HISTORIC AND DESIGN REVIEW COMMISSION

February 17, 2021

HDRC CASE NO: 2021-056
ADDRESS: 134 W MISTLETOE
LEGAL DESCRIPTION: NCB 1837 BLK 15 LOT 1 & W 14.28 FT OF 2
ZONING: R-4,H
CITY COUNCIL DIST.: 1
DISTRICT: Monte Vista Historic District
APPLICANT: Lyndsay Thorn
OWNER: John Archer/ARCHER JOHN CHRISTIAN
TYPE OF WORK: Construction of an ADA ramp, exterior modifications
APPLICATION RECEIVED: January 20, 2021
60-DAY REVIEW: Not applicable due to City Council Emergency Orders
CASE MANAGER: Stephanie Phillips
REQUEST:

2 West Elevation
1/8" = 1'-0"

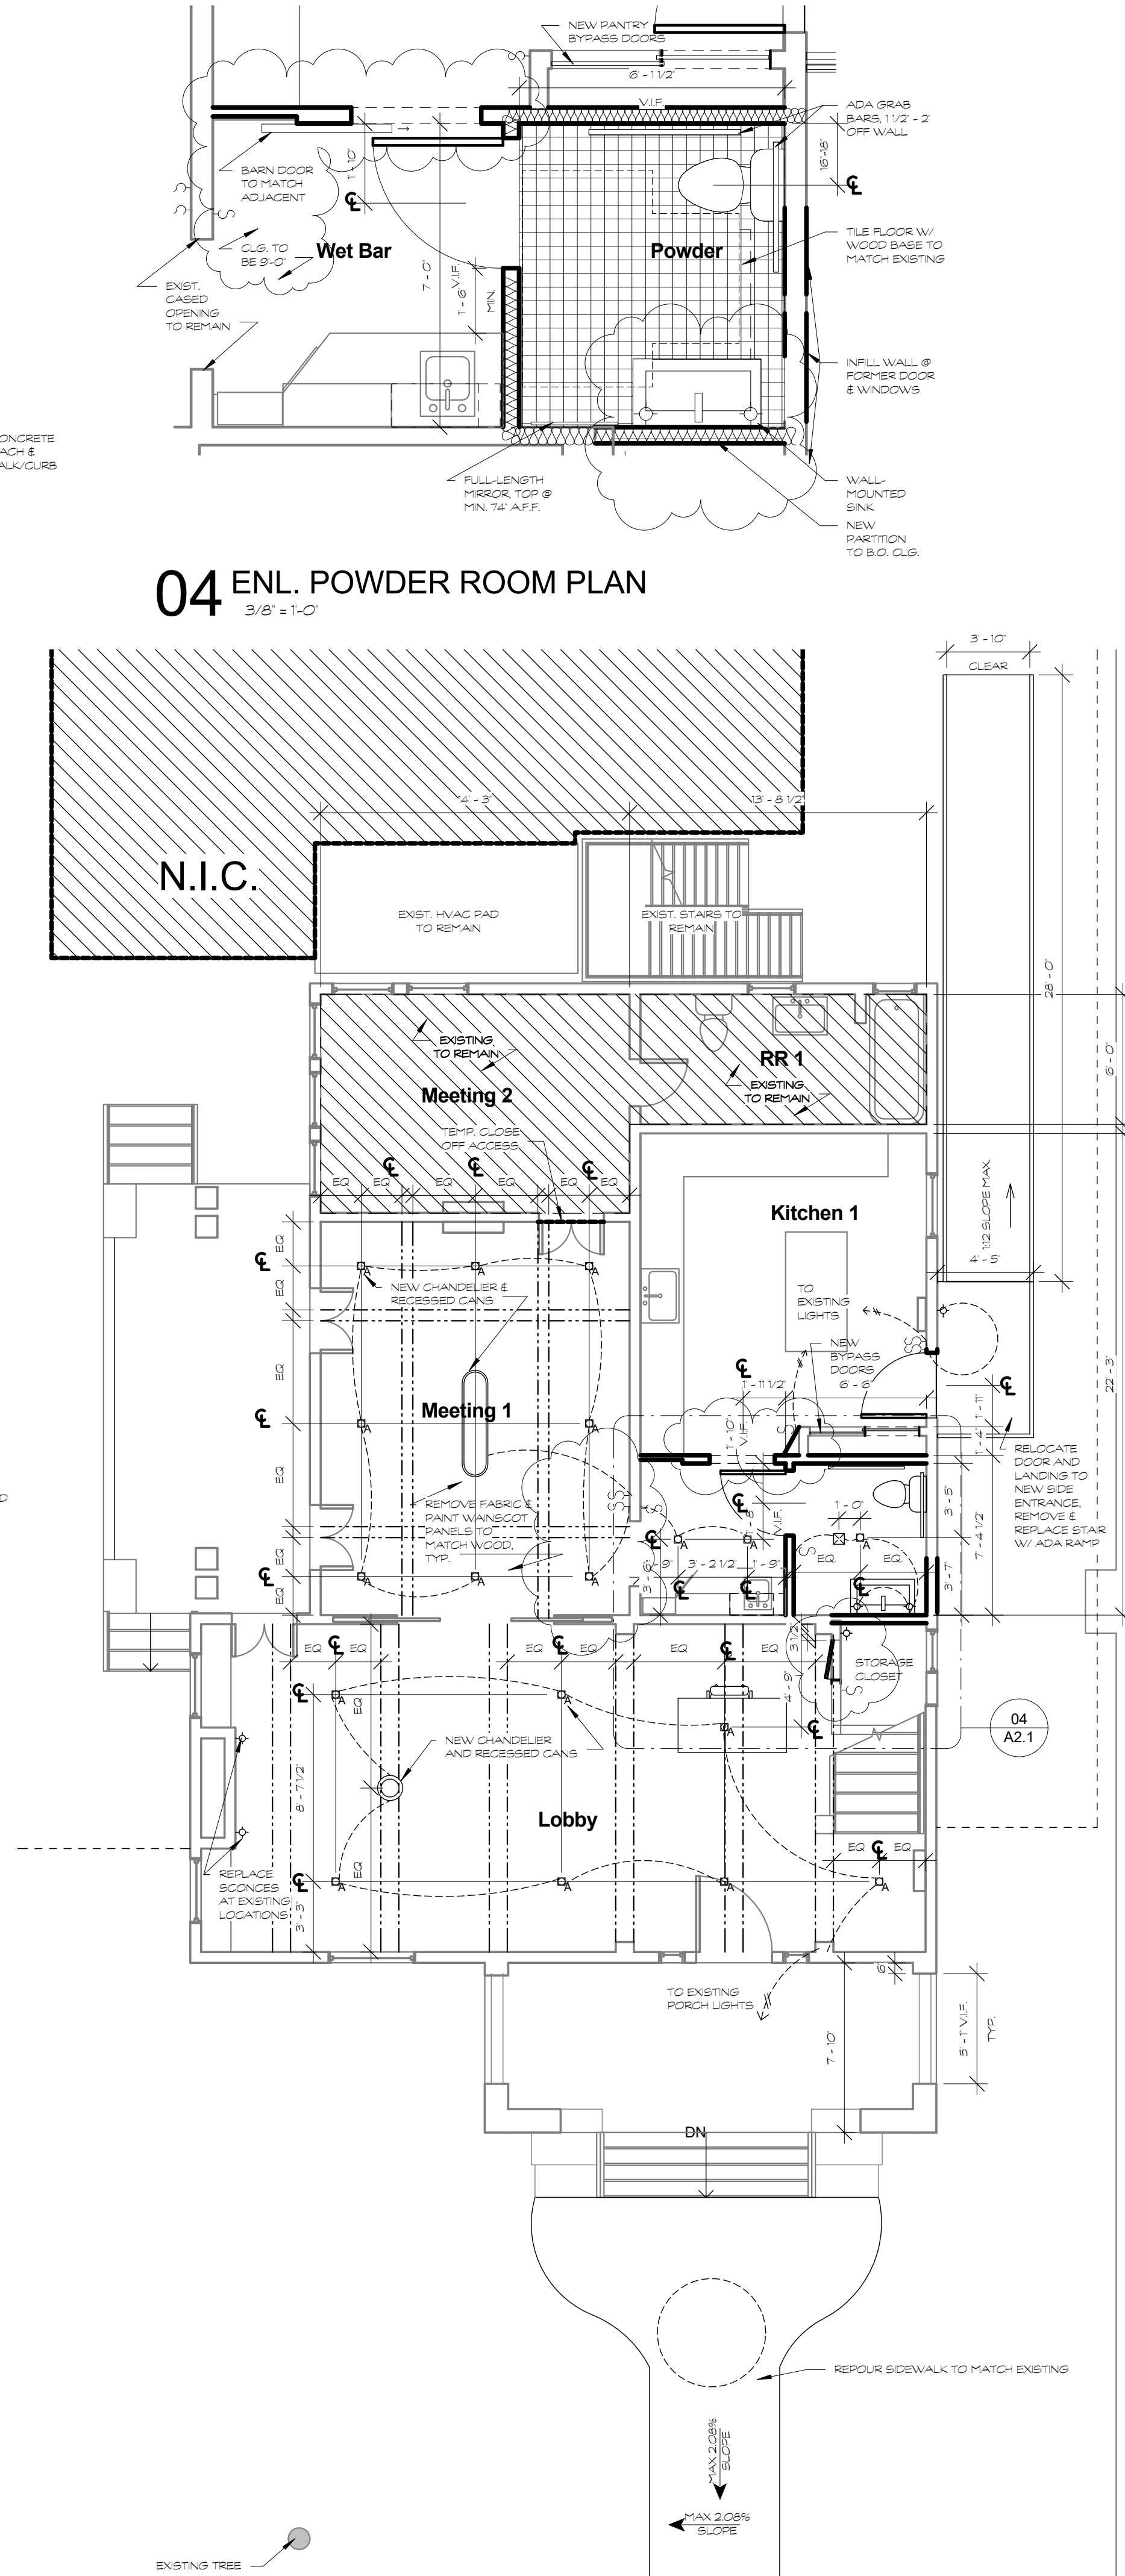
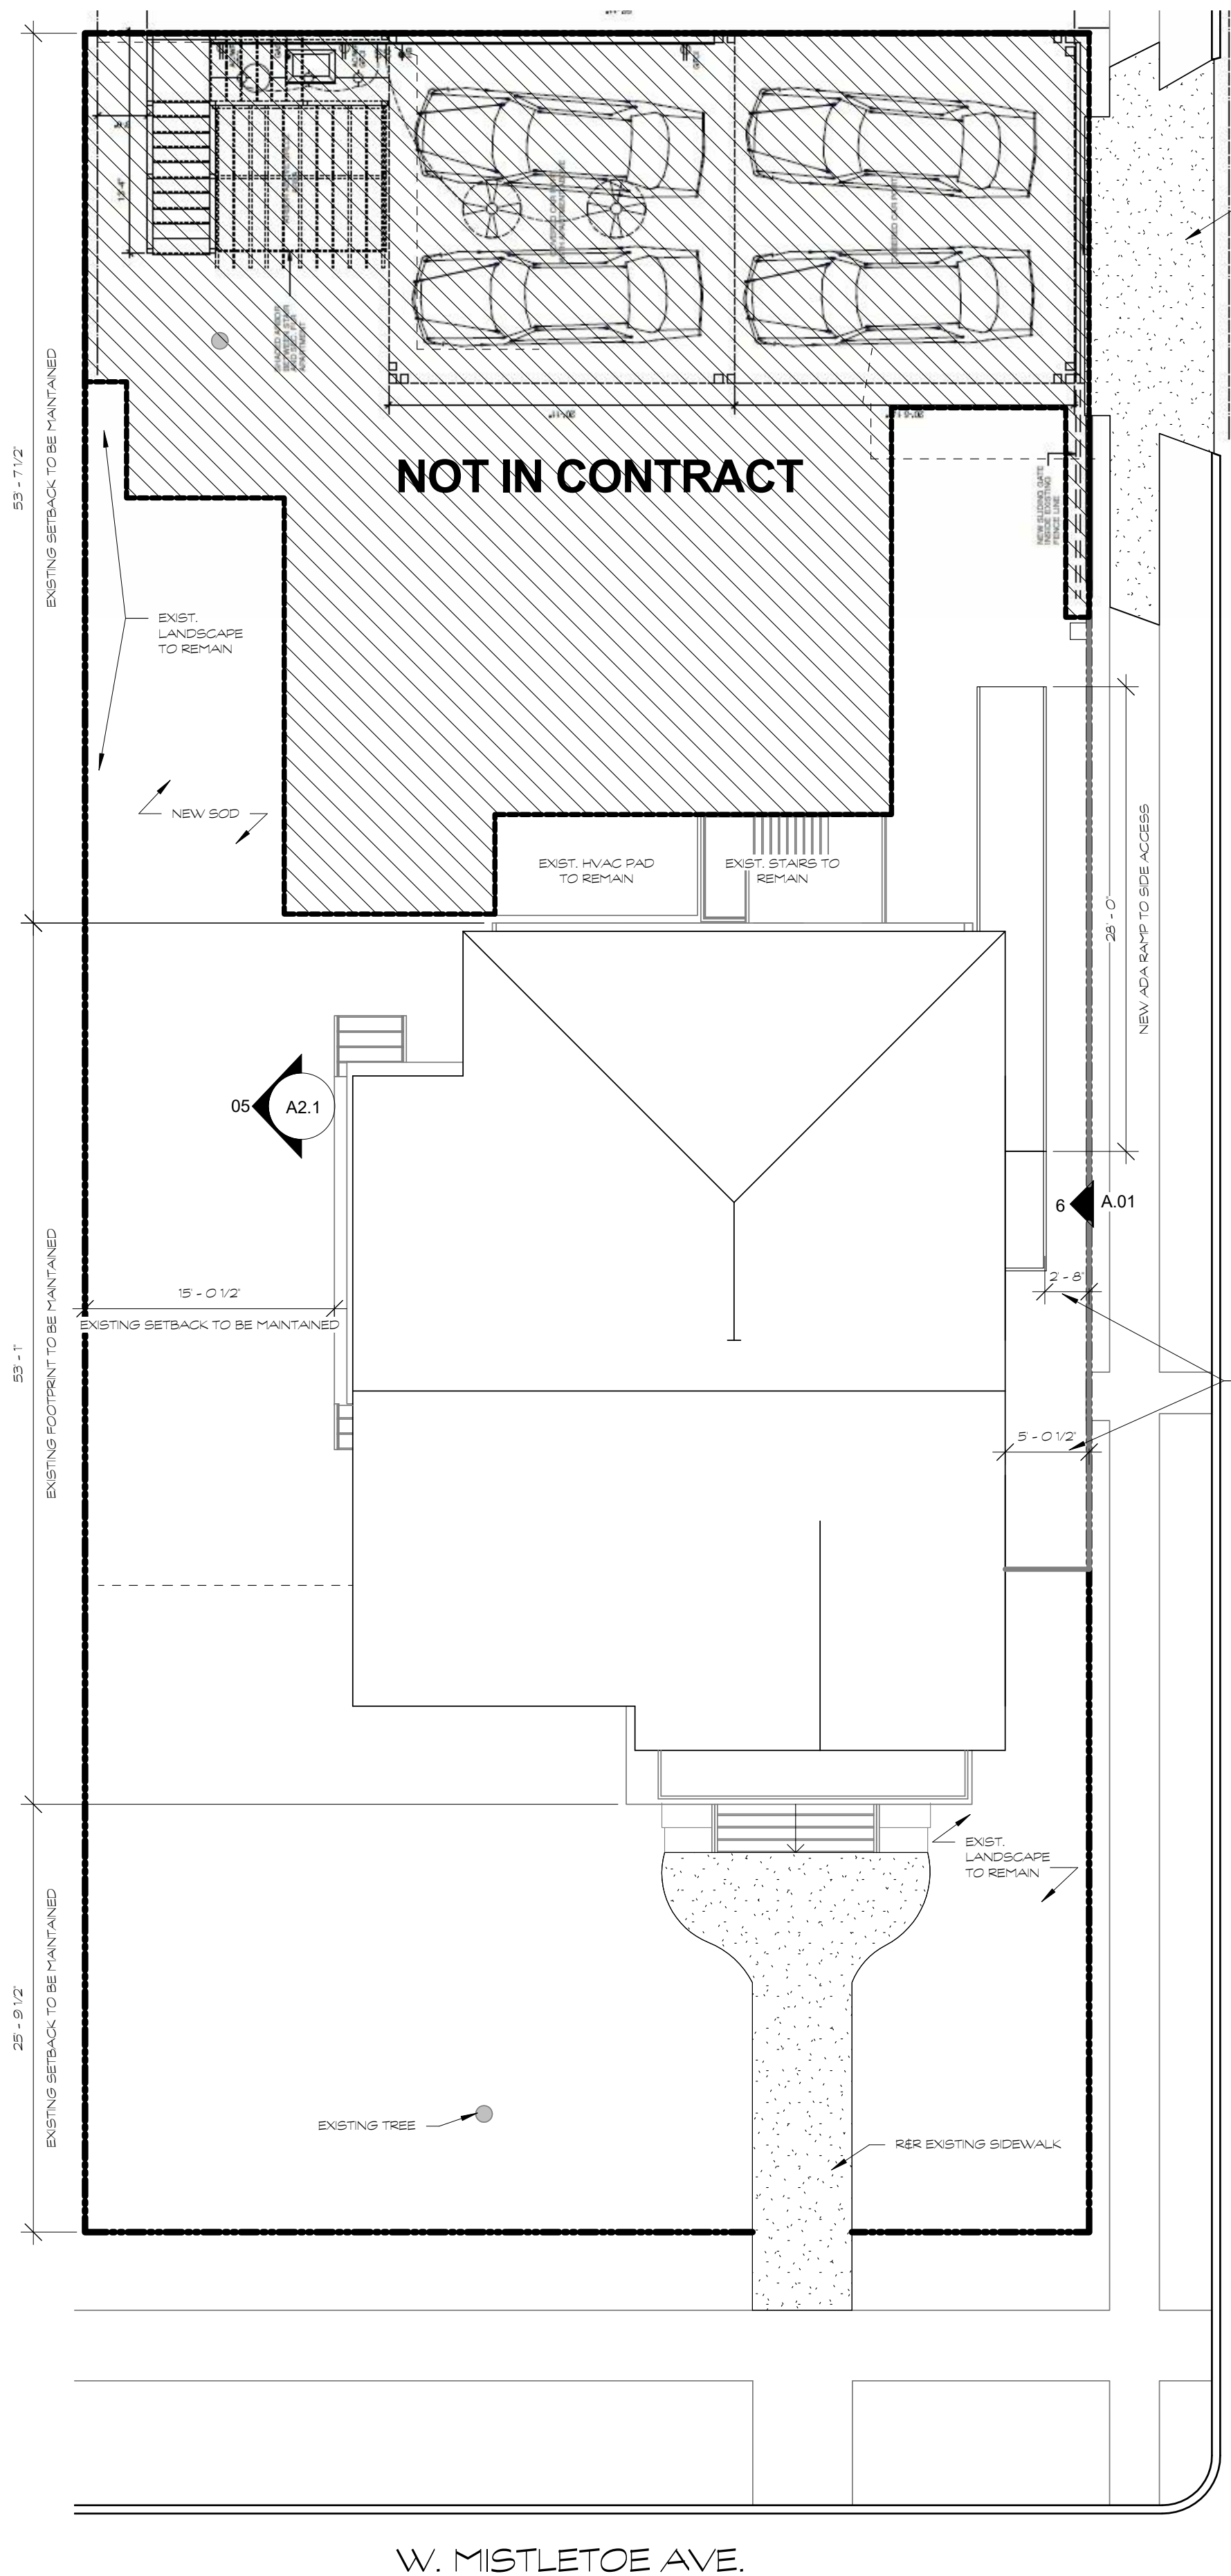
- b. **DOOR RELOCATION AND FENESTRATION MODIFICATIONS** – The applicant has proposed to relocate the existing side access door approximately 8’-8 ½” to the south to replace an existing window. A smaller window will also be removed that is currently adjacent to the existing door. The door is to be relocated to accommodate a new ADA ramp. While altering existing openings is generally discouraged, staff finds that the discreet location of this modification on a side façade, as well as its minimal impact to the overall historic character and fenestration pattern of the building, is appropriate.

- c. **ADA RAMP** – The applicant has proposed to construct a wooden ADA ramp on the west elevation of the home. According to the applicant, these modifications are to allow the owners more accessible entry to the house, while preserving the historic front entrance and providing an opportunity for an accessible restroom off the kitchen at the previous location of the existing door and stairs. A similar railing to the existing will be installed, and the same colors as existing will be maintained on all exterior modifications. According to the Historic Design Guidelines for Site Elements, the preferred location of new ramps is at the side or rear of the building when convenient for the user. Minimize the damage to the historic character and materials of the building and sidewalk while complying with all aspects of accessibility requirements. As noted in finding b, altering existing doors is generally discouraged, staff finds that the discreet location of this modification on a side façade, as well as its minimal impact to the overall historic character of the building, is consistent with the Guidelines.

Staff recommends approval of the request items based on findings a through c with the following stipulations:

- i. That the windows be salvaged and stored on site to be used for repairs or in future construction projects.
